**CALIFORNIA GEOLOGICAL SURVEY  
FAULT EVALUATION REPORT FER 253  
SUPPLEMENT NO. 1**

**THE HOLLYWOOD FAULT  
in the Hollywood 7.5' Quadrangle  
Los Angeles County, California**

by  
Janis L. Hernandez  
Engineering Geologist  
November 5, 2014

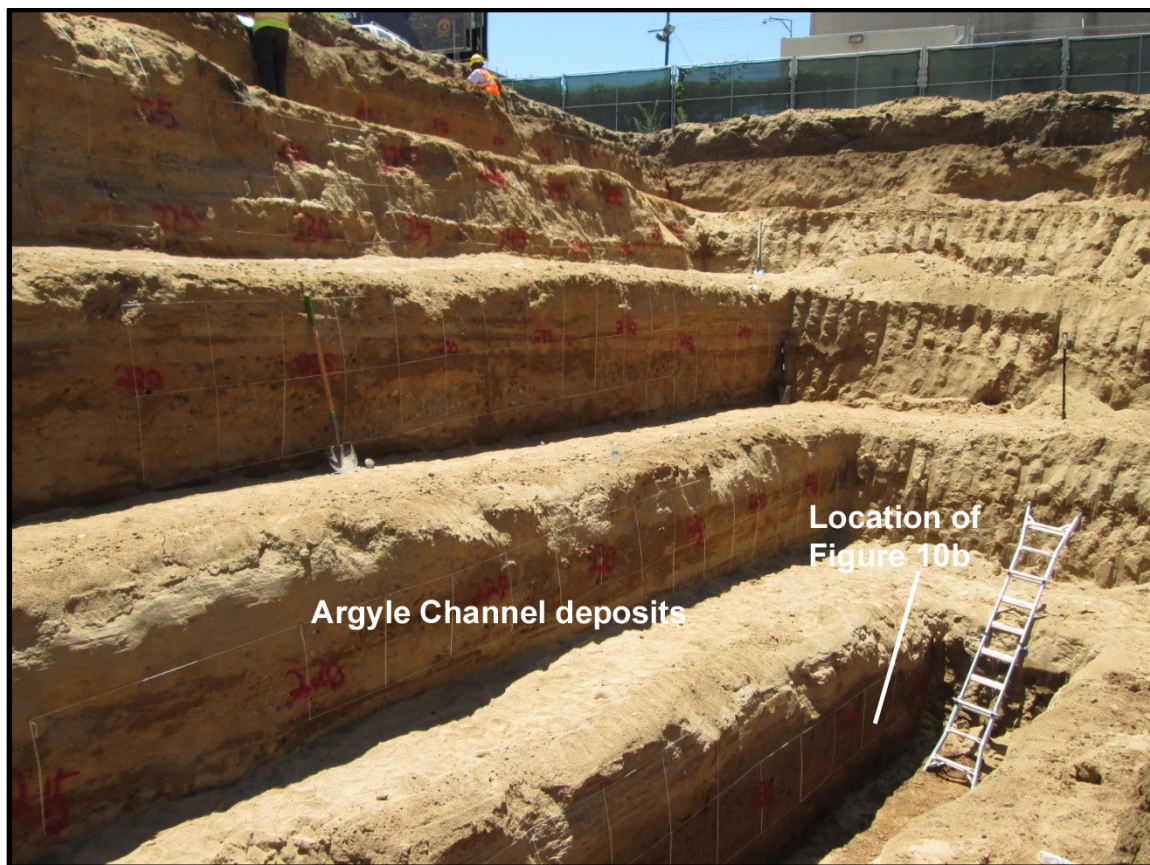
Group Delta Consultants, Inc., (2014d) prepared a limited data report from a Fault Activity Investigation for locality S2-9 (GDC Site 1, Figure 8). Their investigation included core borings, a CPT transect and an approximate 240 foot-long, 30 foot-deep trench on the eastern portion of the site (a southward extension of the trench to the north on site 2). The GDC letter report includes a summary of technical findings that includes a summary of the interpretations for other sites surrounding Site 1. The only data provided in the report are CPT logs and two interpreted CPT profiles. Trench logs, borehole logs and age dating results were not provided. GDC reported an unbroken late-Pleistocene mudflow deposit and overlying Holocene Argyle Channel deposits within Site 1.

***CGS was invited to the site for periodic trench review between June 30, 2014 and July 11, 2014, where we observed unbroken Argyle Channel deposits overlying an older unbroken unit that was tentatively correlated by GDC staff to mudflow deposits observed to the north. In the northern portion of Site 1 near the boundary with Site 2, the late-Pleistocene mudflow unit appears to be draped over the underlying folded debris flow units, and what may be the same unit appears near-horizontal as it extends to the southern end of the trench (Figure 10a).***

**We received no logs of this part of the trench to clarify these relationships.**

**Figures 10a, 10b show the stratigraphy in the south end of the trench. Our review of the CPT data for this site, and some earlier core borings (from GDC Site2) indicates a discontinuous south-dipping Quaternary stratigraphic section, with a prominent stratigraphic break toward the southern end of the property indicative of a fault. The orientation of this break appears to be north-dipping, projects upward toward the ground surface near the southern property boundary (south of the trench exposure), is in alignment with the fault scarp located north of Carlos Avenue immediately to the east, and is in alignment with an inferred fault trace from the Langan data west of Vine Street (locality S2-7) to the west. On the basis of these observations, the southern trace of the Hollywood Fault has been moved to the southern boundary of locality S2-9, just south of the trench exposure.**

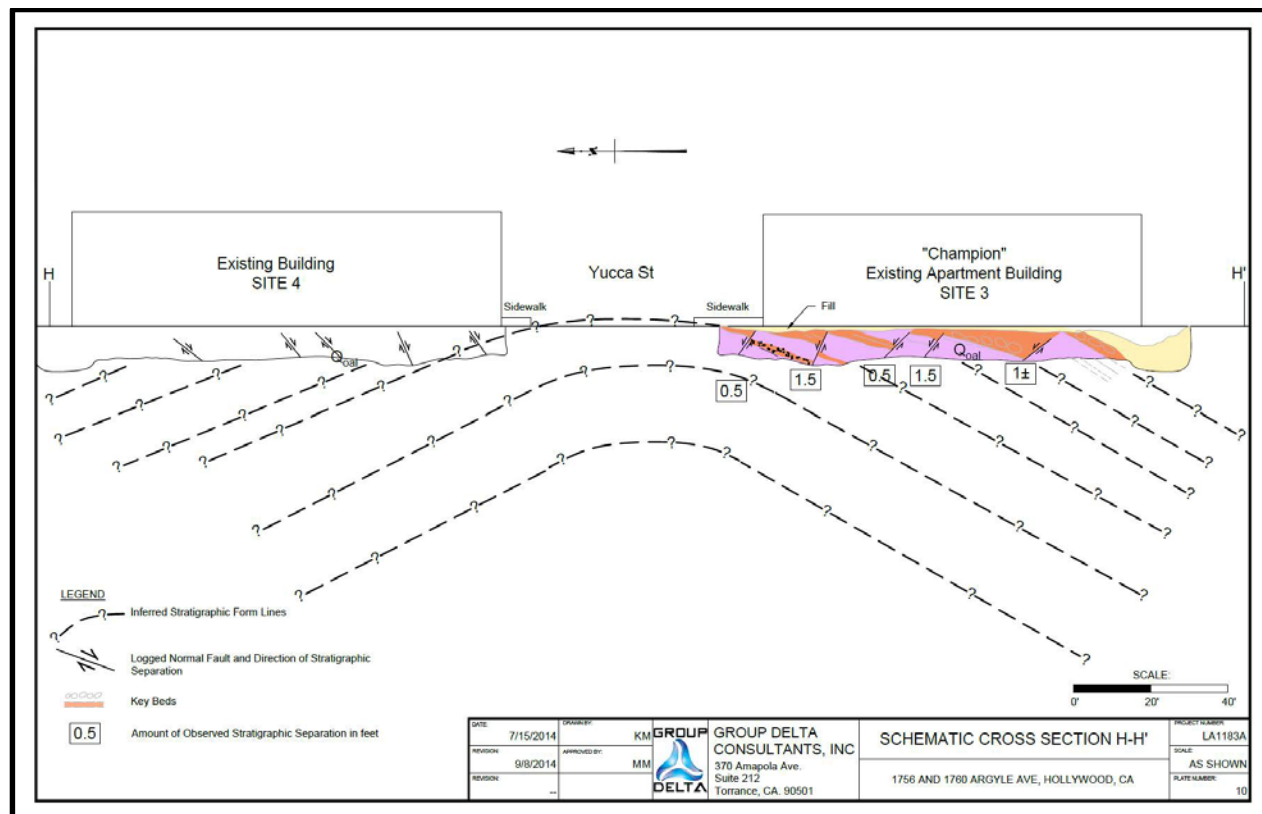
At locality S2-11, (GDC Site 3, Figure 8), Group Delta (2014c) reported the site is underlain by fill materials and older alluvial debris flows, which in turn are underlain by Modelo Formation. Their site investigation included both CPT and core borings, and an approximate 8-foot deep trench on the west side of the site. GDC reported the older alluvial unit consists of Pleistocene debris flows, and state that this unit is faulted. They associated this fault with a localized west-northwest oriented anticline, which extends north to GDC Site 4, as shown in their cross-section (Figure 11). They interpret these features to be due to regional transpression and not to seismogenic faults. They report the age of the faulting at this site is older than 35 ka based on unbroken mudflow deposits found to the west at Site 2.

***The data presented in the GDC report is consistent with the interpretation that the deposits are of Pleistocene age although it is unclear why these “debris flow” deposits are differentiated from the similarly comprised and deformed older alluvial fan unit exposed and described at site 2.***

**Interpretation that the faults are local bending moment faults is not consistent with CGS field observations within the trench. CGS noted a significant lack of correlation across the southernmost fault, and that thickness of units changed across most of the faults, which indicates a component of lateral displacement (Figure 12). The southernmost fault appeared to be a prominent fault, as correlative units across the fault were not found, suggesting this fault trace may have seen the most displacement. No evidence for, or against, Holocene faulting was reported on this site because Holocene deposits, if present, were likely removed during site development.**

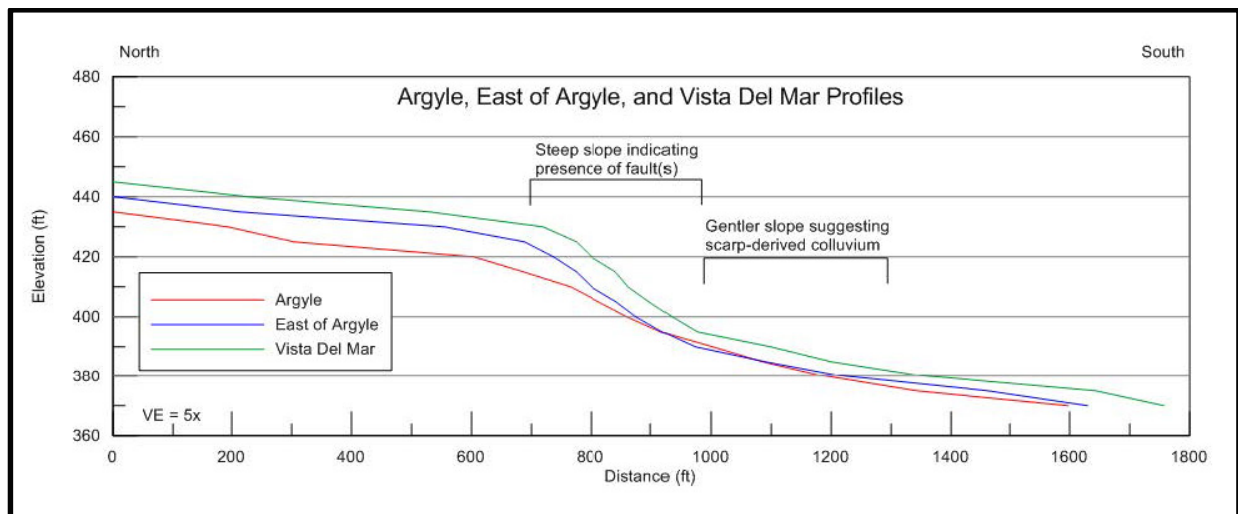
A comment was submitted by Lettis Consultants International, Inc. (LCI), accompanied by a transmittal letter by Elkins Kalt Weintraub Reuban Gartside, LLP on April 8, 2014 to the SMGB to specifically address the BLVD 6200 property located at 6201 Hollywood Boulevard in Hollywood (locality S2-12, Figure 7). In their report, they present data and analysis of the site and vicinity, with additional focus on the southern, discontinuous trace of the Hollywood Fault that is mapped on the Preliminary EFZ map to underlie the site. LCI presented detailed topographic profile analyses consisting of 3 sets of data including: review of historical 6-minute topographic maps, high-resolution lidar imagery, and high resolution ground survey topographic profiles along 8 closely-spaced, north-south oriented streets. These profiles were located within the streets adjacent to the BLVD 6200 site and along other nearby profile lines. They identified breaks in slope within the profiles of these transects, and included locations of scarps previously mapped by Dolan et al. (1997), the projection of fault traces mapped by CGS in FER 253, and the BLVD 6200 project boundary.

LCI stated that in addition to the prominent break in slope located immediately north of their site, a subtle break in slope is expressed across the southern portion of the site. They reported this southern slope break is located south of the southern discontinuous fault trace mapped by CGS. They suggest that subtle breaks in slope can be related to several factors: change in slope direction on the ground surface, or thickness and directional changes within the alluvial fan system. Their analysis noted that the subtle slope break is coincident with an east-west trending apparent scarp mapped by Hill et al. (1979), and a possible fault scarp mapped by Weber et al. (1980). In their review of the 1926 topographic maps, they indicated that Argyle Avenue did not yet exist at this location, and that possibly the subtle break in slope observed in the street may have been created during subsequent construction of Argyle. Alternatively, they concluded that this subtle break in slope reflected in the composite topographic profiles (Figure 13), is most likely related to scarp-derived colluvium from the steep break in slope to the north.

***The data presented in the LCI report was particularly helpful in CGS review of topographic breaks in slope. Fault traces mapped by CGS in this area were based on geomorphic interpretation using similar data as used by LCI, as well as fault traces from Dolan et al. (1997), Hill et al. (1979), and Weber et al. (1980). In addition, the southern discontinuous fault trace was mapped using original subsurface data from Geotechnologies, Inc. (2006) that included logs of borings and the site topographic base map. CGS review of the high resolution street survey data submitted by LCI in their report, and detailed observations included in the Geotechnologies (2013) report, finds justification to modify our interpretation of the location of the principal southern fault trace.***

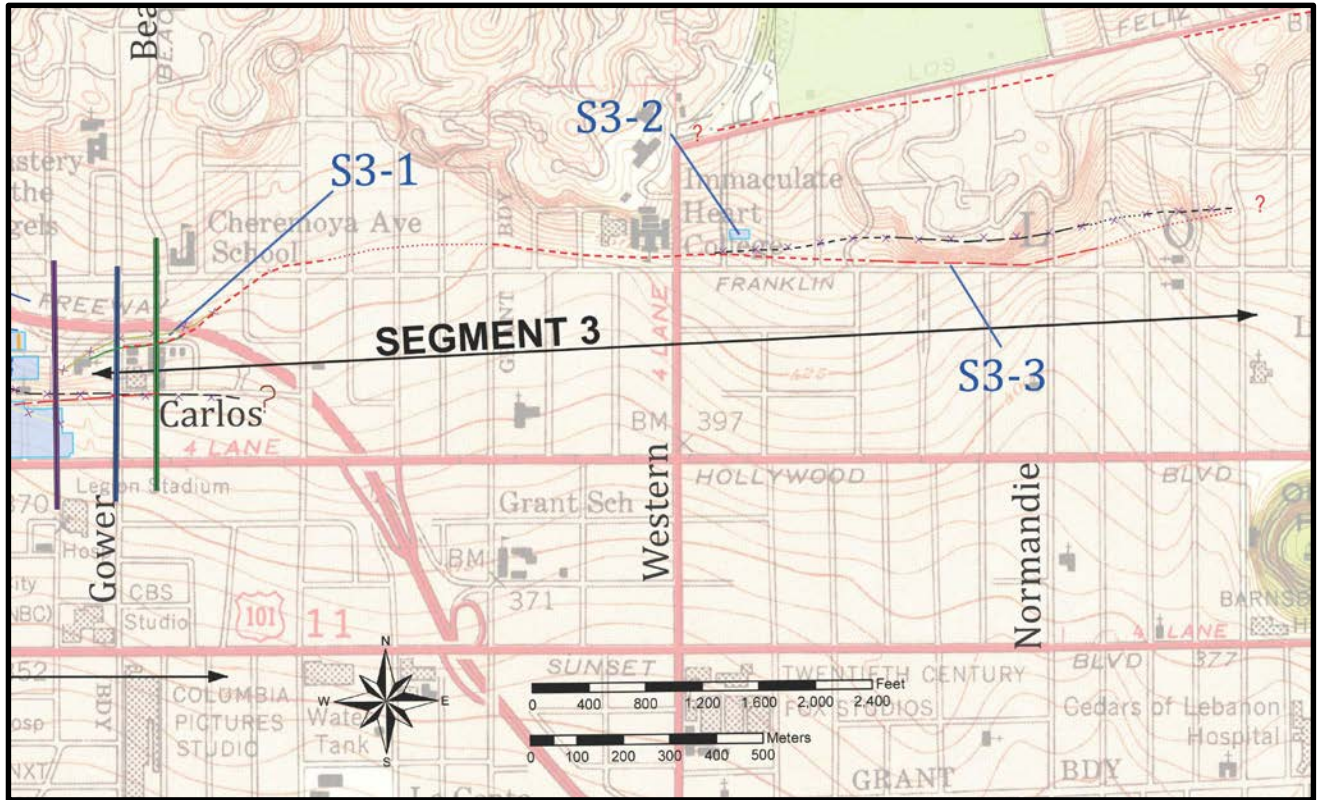
***As described above, LCI (2014) prepared several topographic profiles along north trending streets in the vicinity Yucca Street and Argyle Avenue, which included portions of both Segments 2 and 3. Their analysis included identification of breaks in slope in the area of locality S3-1 (Figure 14). LCI inferred these features were attributed to either: tectonic fault scarps (steep breaks), or alluvial fan or colluvial deposits eroding off the fault scarps (subtle breaks).***

At locality S3-3 (Figure 14), CGS revised the location of the Hollywood Fault trace along Franklin Avenue east of Western, based on a review of the 1926 topographic map covering this area. Our initial interpretation in this area utilized a later version of the topographic map, where topographic details were more subtle. Our reinterpretation of the fault trace follows closely with the trace mapped by Dolan et al, 1997.

***The data presented in the LCI report is helpful for reviewing the magnitude of breaks in slope as they trend from west to east across this portion of Hollywood. As a result, the western portion of the fault trace along Segment 3 appeared to be mapped a few feet north of the base of a subtle break slope, as indicated in the LCI profiles. We have modified the fault trace closer to the base of the slope break as shown in Figure 14. This modification has no effect on the EFZ boundary at this location.***

**As a result of this minor adjustment, the EFZ boundary has shifted slightly to the south.**

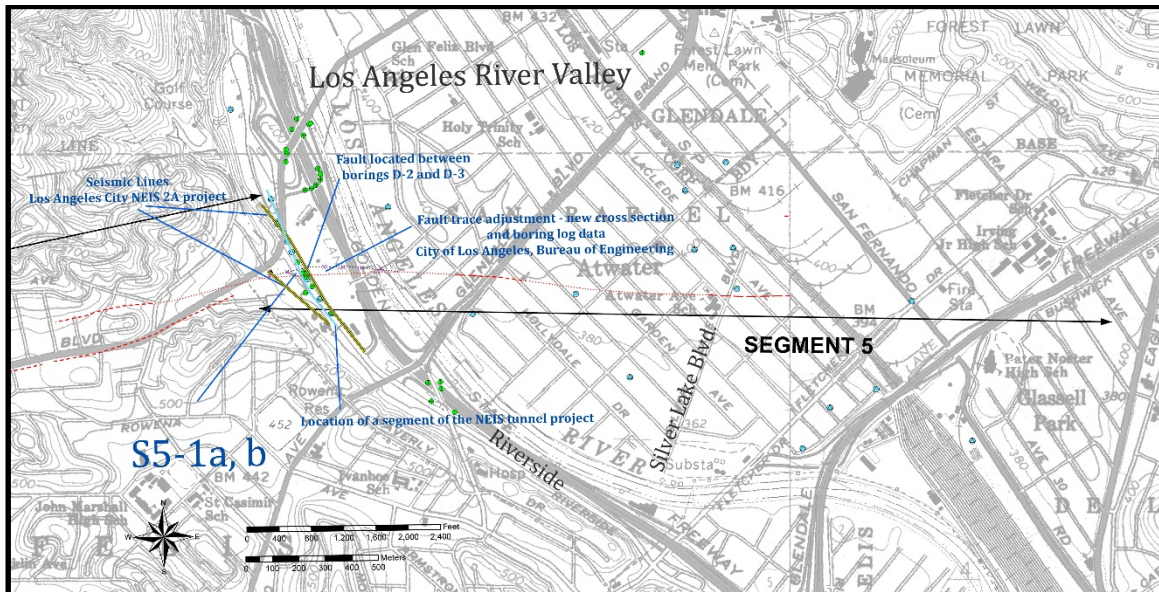
David L. Perry, comment letter dated April 18, 2014: Mr. Perry submitted a comment to the SMGB on April 18, 2014 regarding the location of the Hollywood Fault and analysis of the supporting data from the Northeast Interceptor Sewer (NEIS2A) project area (locality S5-1a) as shown on Figure 15. In this letter, Mr. Perry reports the cross-section utilized in the FER (from the Los Angeles Department of Public Works, 2013) is vertically exaggerated, and includes borings that were projected up to 63 feet horizontally into the section. In the AMEC (2013) report, he states there is a cross-section drawn at a 1:1 scale, and acknowledges subsequent boring data performed by the City of Los Angeles Department of Public Works (City of Los Angeles, 2013) was included in the cross section utilized by CGS for the FER. Mr. Perry's interpretation of the data, and his extensive experience in this area suggests the "thickening of young alluvial deposits within the fault zone" as reported by CGS, is likely attributed to paleochannels from the Los Angeles River system, and that the projection of the data into the cross-section should include consideration of geomorphology and paleochannel geometry.

Patrick Schmidt, and Fred Burnett, (2014): Mr. Schmidt and Mr. Burnett of the City of Los Angeles Bureau of Engineering (BOE) provided CGS a technical paper they prepared in February, 2014 that was submitted to the Underground Construction Association's North American Tunneling Conference (NAT). In this paper, they discussed some of the exploratory methods implemented during the Northeast Interceptor Sewer project (NEIS), including: borings with down-hole geophysics, packer and pressuremeter testing, CPT testing, Remi surveys and surface geophysics lines. They reported some of the difficult conditions they anticipate encountering during tunneling along the fault zone, including: squeezing and running ground conditions, high methane gas concentrations, and up to 5 bars of water pressure. They reported the main Hollywood Fault was located between exploratory borings M08-B4 and M08-B5, where interpolation of the geophysical surface survey data identified two north dipping fault planes with three south-dipping secondary faults in the hanging wall that merge at depth.

***We reviewed Mr. Perry's comments, and appreciate the insight he provides in this area, and particularly with his experience on the NEIS project. Regarding projection of data into the NEIS profile, we acknowledge the thickness variation of recent alluvium in the vicinity of subsurface faulting may be due to erosion processes, and paleochannel morphology along the ancestral Los Angeles River system.***

***This technical paper describes conditions the City of Los Angeles BOE will encounter during tunnel excavation operations. No additional details regarding active faulting either outside or within the tunnel alignment were noted. However, their description of difficult tunneling conditions keys into the general width and local structure of the fault zone along the west bank of the Los Angeles River Valley.***
